Technical Bulletin

DP02	TB0005-2006	Elan Motorsports Technologies	
From:	Christian Rushforth		
Subject:	Fire Bottle Mounting	Date:	November 20 th , 2006

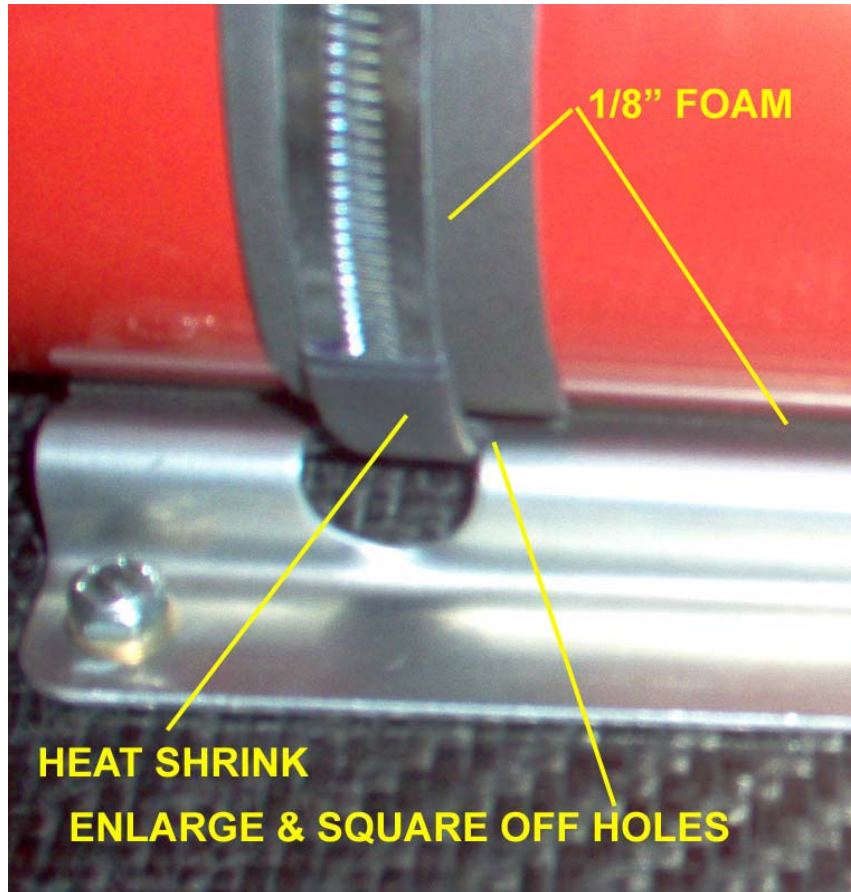
Elan has identified an issue with the fire bottle mounting and hose clip installation on cars #1 through to #15. After some periods of running the hose clips holding the fire bottle to mount may break causing the fire bottle to become detached in-turn leading to loss of extinguishment

It is recommended that all teams modify their fire bottle mounting and clips to the following specification

1. Through holes in fire bottle mounting bracket to be enlarged and made square so that the hose clip does not contact on two points. Current holes are circular in manufacture which aggravates the issue of the band clamp picking up.
2. Line fire bottle mounting bracket and underneath hose clamps with approx. 1/8" thick foam
3. Hose clamps that may come into contact with mounting bracket to have heat shrink material added to them.
4. Do not over-tighten band clamps
